UNITED STATES PATENT AND TRADEMARK OFFICE

Office Action Summary

10/723,419

DETAILED ACTION

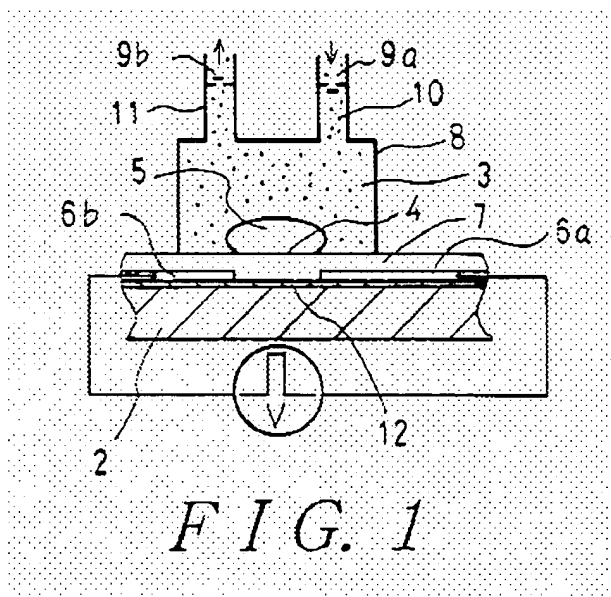
7. Claims 1-4 and 10 are rejected under 35 U.S.C. 102(b) as being anticipated by **SHIRAISHI** (U. S. Patent No. 6,071,081).

SHIRAISHI discloses a device capable of use for determining a boiling point of a hydraulic fluid of a hydraulic system, and, regarding Claim 2, the device being capable of use for determining a boiling point of a brake fluid of a braking system in a motor vehicle comprising:

a micropump (Fig. 1) including a chamber 8 containing the fluid (liquid 3);
an electrical heating element (12, 7) situated in the fluid, the electrical heating element (12,7) acting as an actuator of said micropump and being situated in said chamber 8 thereof.

Further regarding Claim 4: SHIRAISHI discloses the device according to claim 3, wherein the chamber has an inlet 9a and an outlet 9b, which are situated in one of the substrate and the cover (See Fig. 1, below; considering generally element 8 the cover, having the inlet and outlet ports, and the substrate includes element 7).

Further regarding Claim 10: SHIRAISHI discloses the device has a multilayer construction (See Fig. 1, above; wherein elements 2, 12 and 6 constitute a multiplayer construction).
